**Compton Community College District
Geotechnical and Soils Investigation Report
For
Campus Public Safety Building**

- 1. Original Report Prepared by GeoTek, Inc. dated October 24, 2016**
- 2. Supplemental Geotechnical Report and Evaluation regarding over-excavation requirements dated January 16, 2017 prepared by United-Heider Inspection Group**
- 3. DSA form 109 Transfer of Responsibility: Geotechnical Engineer from GeoTek to United-Heider Inspection Group dated January 27, 2016**
- 4. CGS First review letter dated January 30, 2017**
- 5. United-Heider Response to CGS first review letter dated April 5, 2017**
- 6. CGS Second review letter dated May 1, 2017**
- 7. United-Heider Response to CGS second review letter dated June 2, 2017**
- 8. CGS Third review letter and approval dated June 14, 2017**

Subject: Response to CGS January 30, 2017 Review Letter
Compton Community College – Public Safety Building
1111 East Artesia Boulevard, Compton, California 90221
United-Heider Project# 10-17036PW

Compton Center - Public Safety Building 1111 E. Artesia Blvd Compton, California	United-Heider #10-17036-PW	March 2017
	Flood Hazard Map	Figure 6

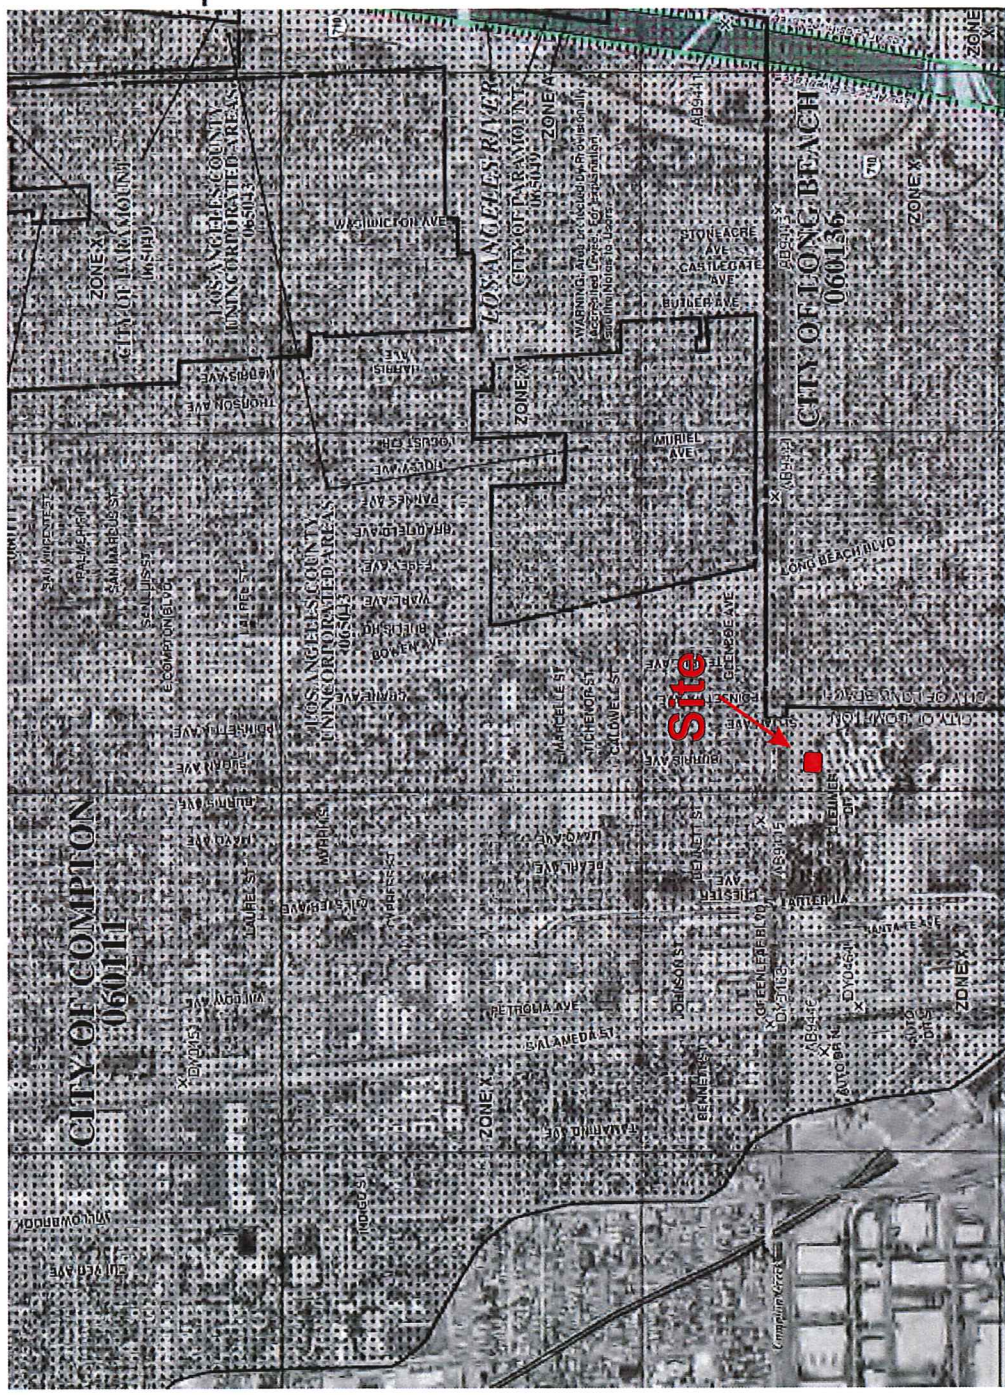
Comment, Note 48, #31-C:

Flooding: We evaluated the project site which did not appear to be subject to significant flooding. As shown on the attached *Figure 6, Flood Hazard Map*, FEMA (2008) has mapped the proposed building location as within Zone X (dot); i.e., a flood-hazard area which is within the area of 0.2% annual chance floodplain, areas of one percent annual chance flood with average depths of less than one foot or with drainage areas less than one square mile. Therefore, the site is considered to have a relatively low hazard of significant flooding. An in-depth engineering evaluation of the flooding potential of the site is beyond the scope of this study or our expertise, and a flood specialist should be contacted if a more in-depth flooding analysis is desired.

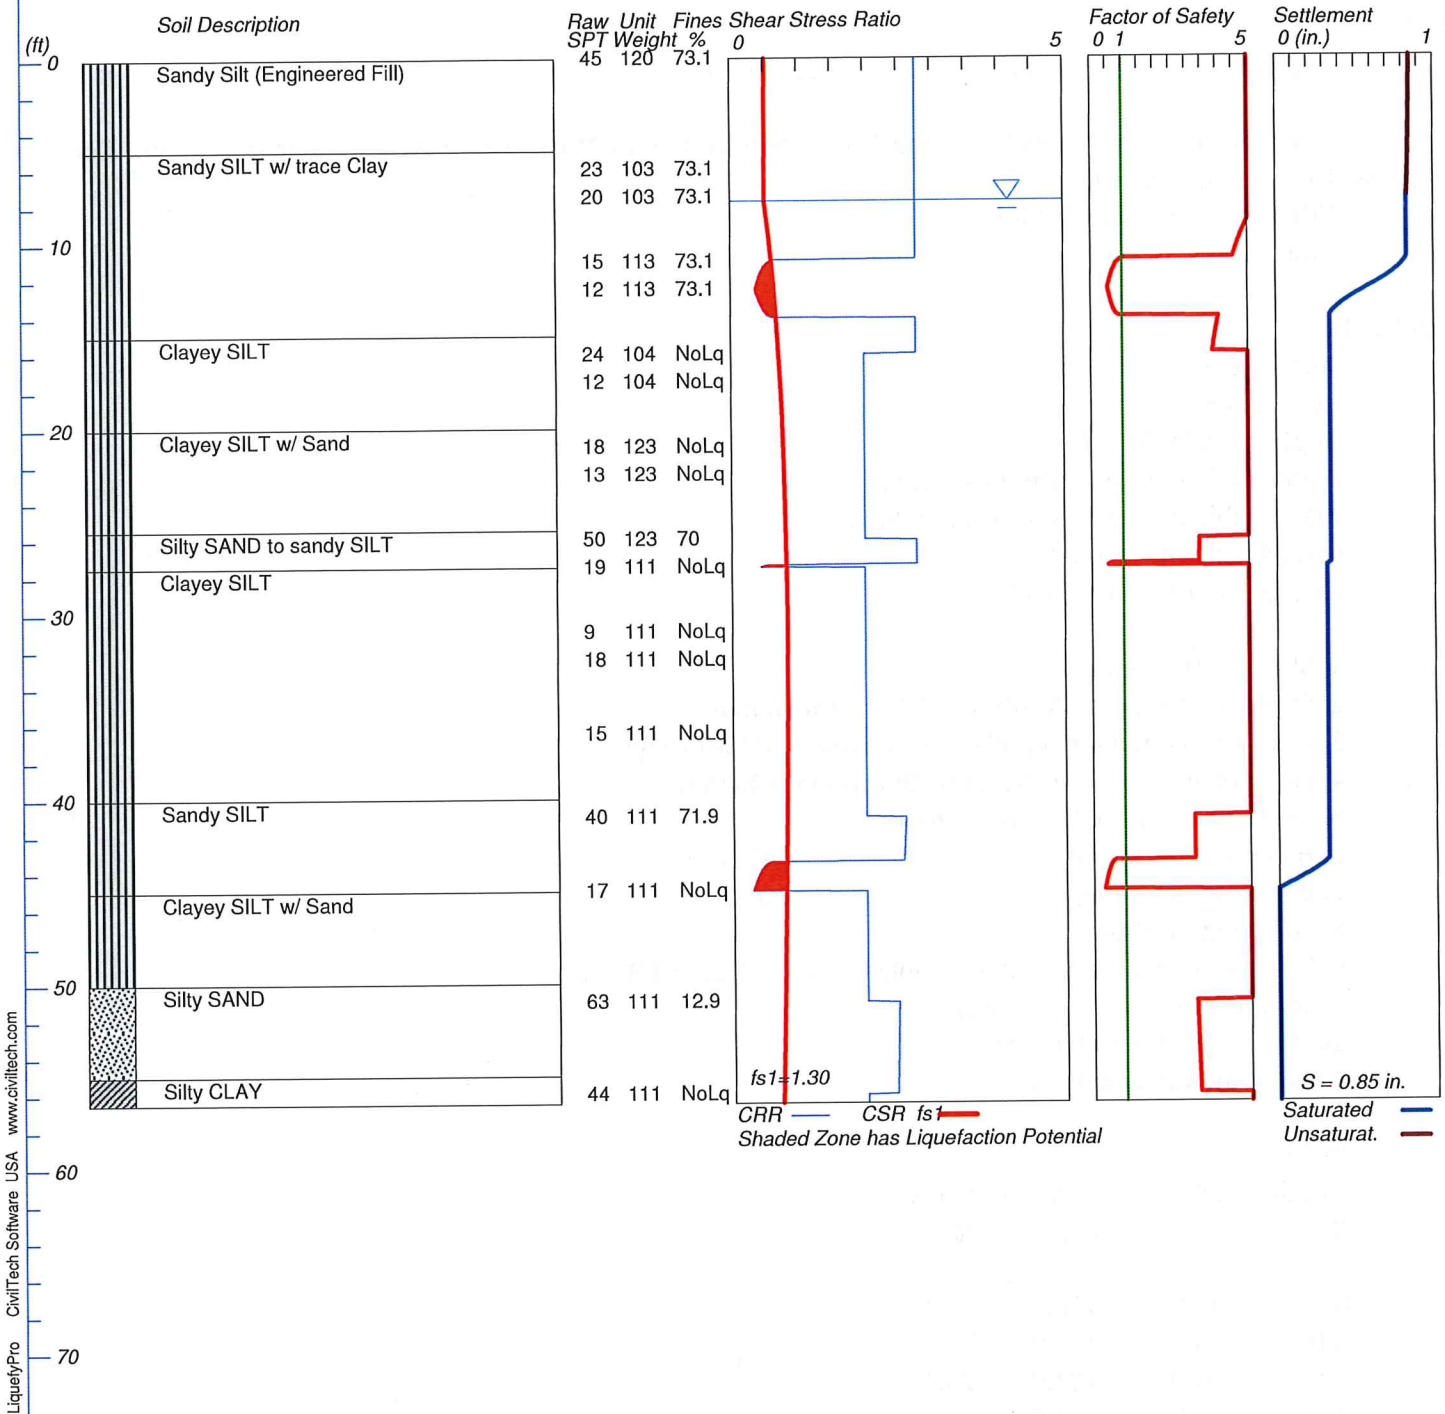
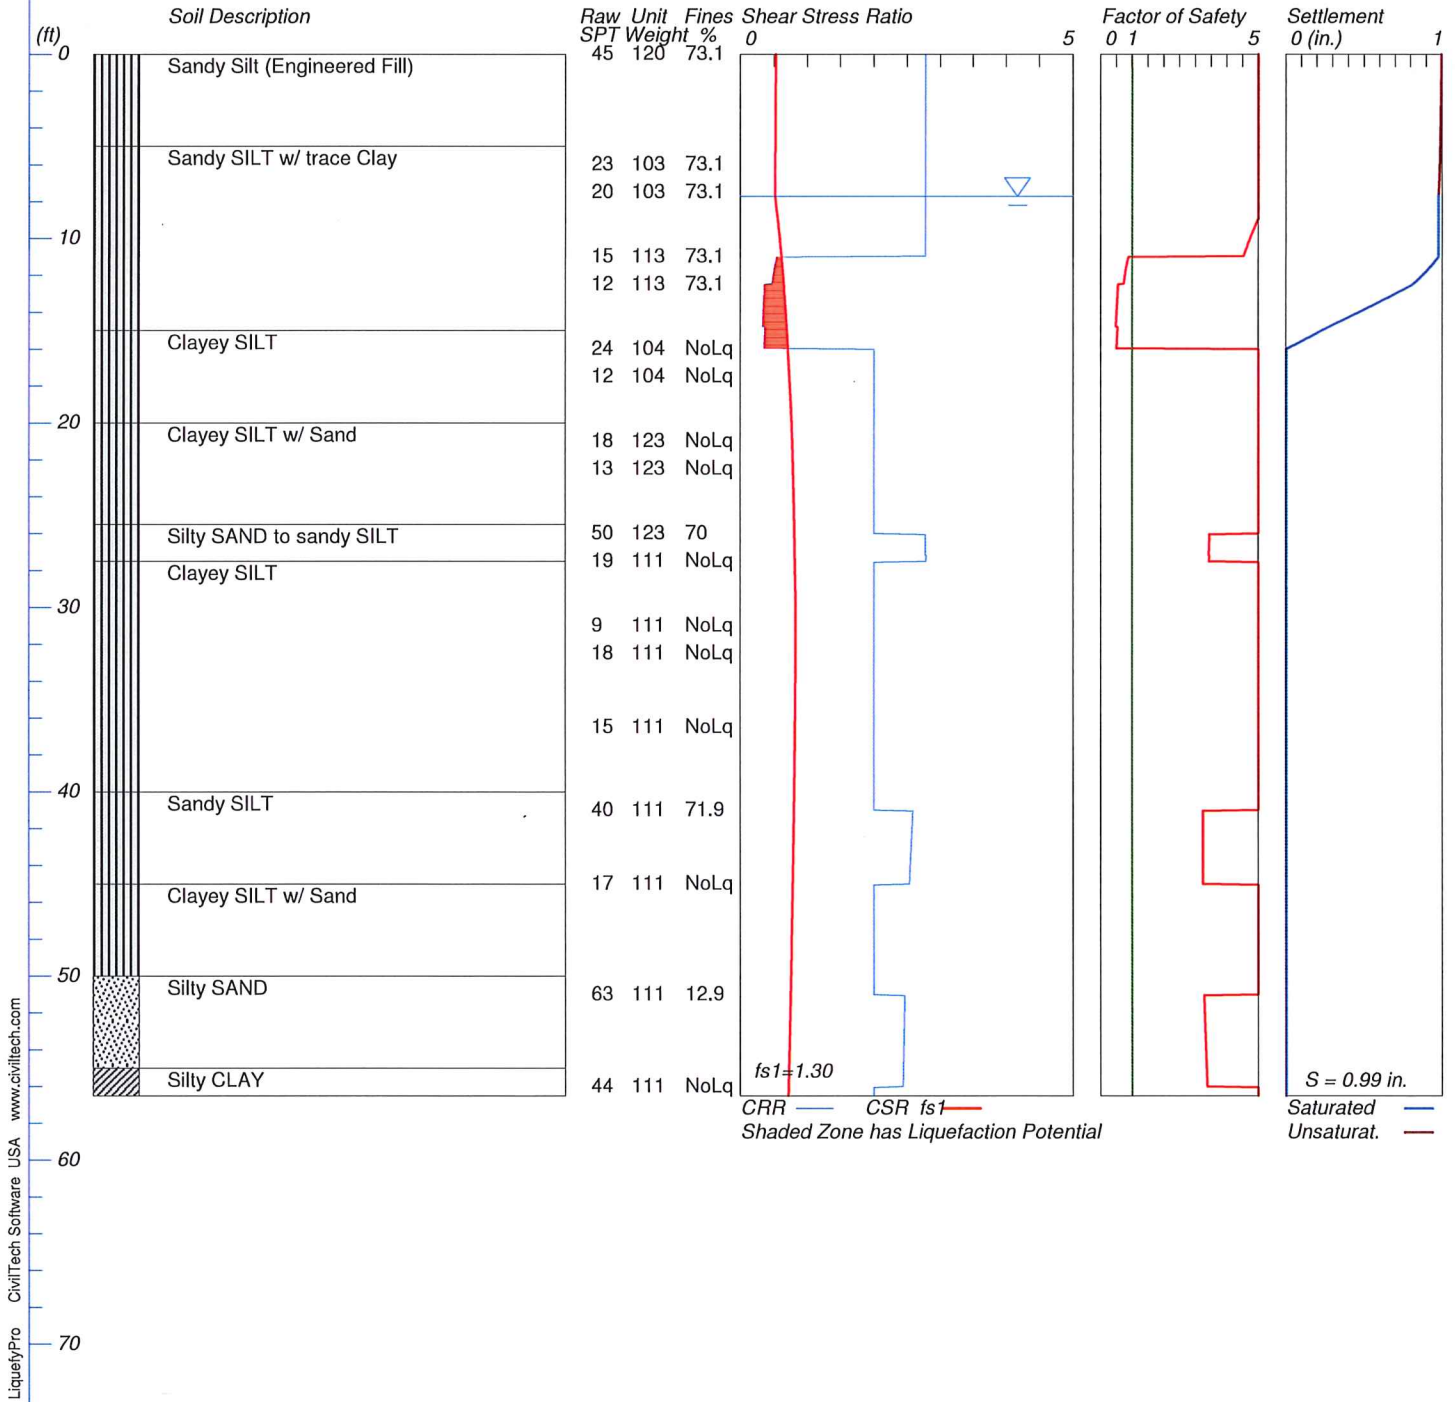
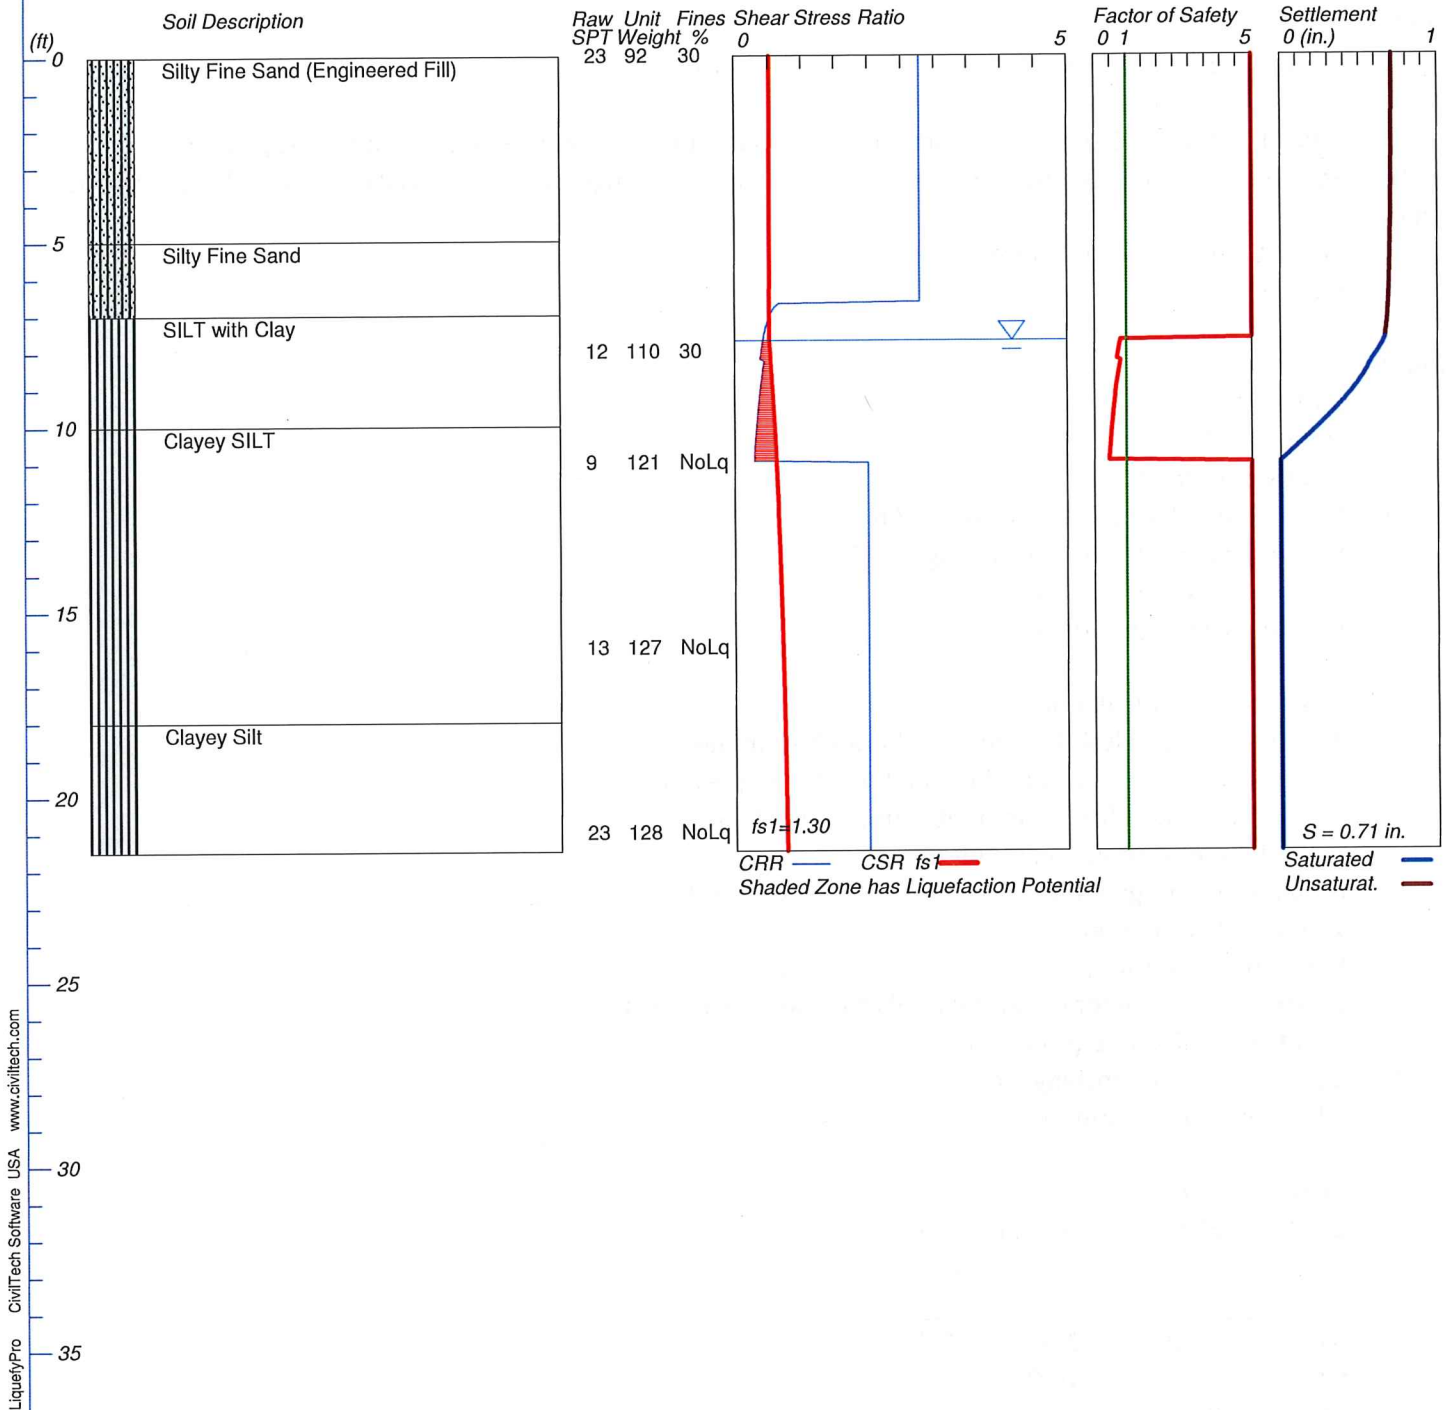
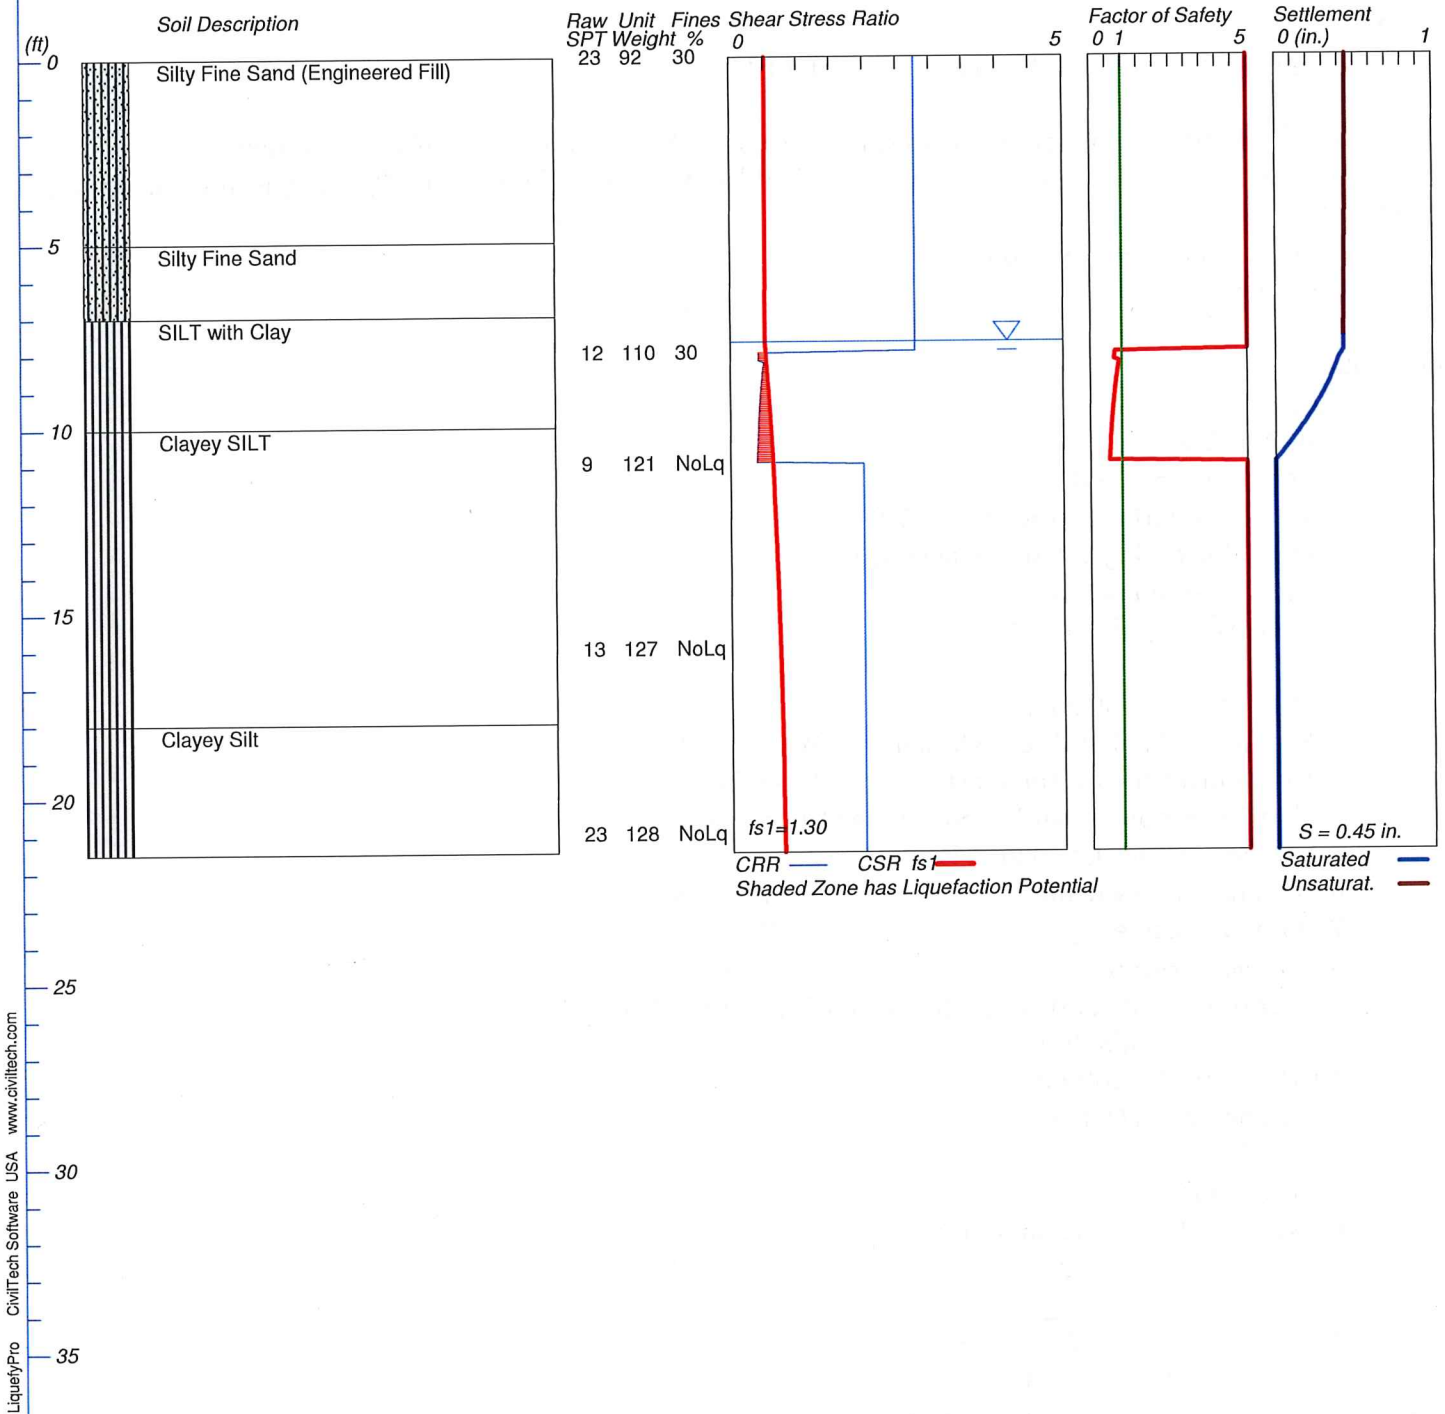
United-Heider provides an updated liquefaction analysis based on data from GeoTek's boring B-1 and several revised input parameters. The earthquake magnitude was reduced from 7.5 to 6.6, which appears reasonable based on the deaggregation provided. The sampler correction factor was increased from 1.0 to 1.2, which presumes the SPT samplers used by GeoTek, Inc. could accept liners but were unlined. The borehole diameter correction factor was also increased from 1.0 to 1.15, which is consistent with an 8-inch diameter boring; however, CGS notes the boring was drilled with hollow-stem-augers and the borehole correction factor should represent the **inner diameter** of the hollow stem per Section 5.4.3 of the SCEC Guidelines for Implementation of SP 117. CGS also notes the "curve smoothing" function was again selected in the analysis. As noted in our original review letter, this function assumes uniform gradual transitions between discrete samples depths, which does not appear applicable for the abrupt transition expected between the fill and the alluvium. The higher blow counts recorded at 5 to 6.5 (and possibly the immediately underlying sample) in B-1 are apparently representative of the undocumented fill cap with respect to lower blow counts in the underlying native alluvial soils. Similar conditions are also apparent in boring B-3. *The consultant should provide revised liquefaction and seismic settlement analyses considering an appropriate borehole diameter correction factor. The consultant should justify the use of the "curve smoothing" function with respect to the fill/alluvium contact or ignore this option in the revised analyses. The consultant should verify with GeoTek, Inc. that the SPT samplers they used for B-1 had space for a liner but were unlined. The consultant should also provide a summary table showing adjusted blow counts at depth for each correction factor, including the fines correction factor, for review. The consultant should provide updated recommendations for differential settlement, as needed, based on the updated analyses.*

In addition to these factors, we re-evaluated the seismic parameters used for liquefaction analysis. Based on our revised parameters, a Peak Ground Acceleration (PGA) of still 0.62g is applicable. However, Moment Magnitude (M) to cause this peak acceleration was found to be 6.6M which is evident from Probabilistic Seismic Hazard Deaggregation on NEHRP Site Class D; see attached Deaggregation figure for PGA. Using these parameters as input, we performed a liquefaction analysis on Boring B-1 using the Liquefy-Pro V5.5b developed by CivilTech Software. Based on the liquefaction analysis calculated results, total estimated vertical settlement of 0.96 inches and differential settlements from 0.48 to 0.63 inches were obtained.
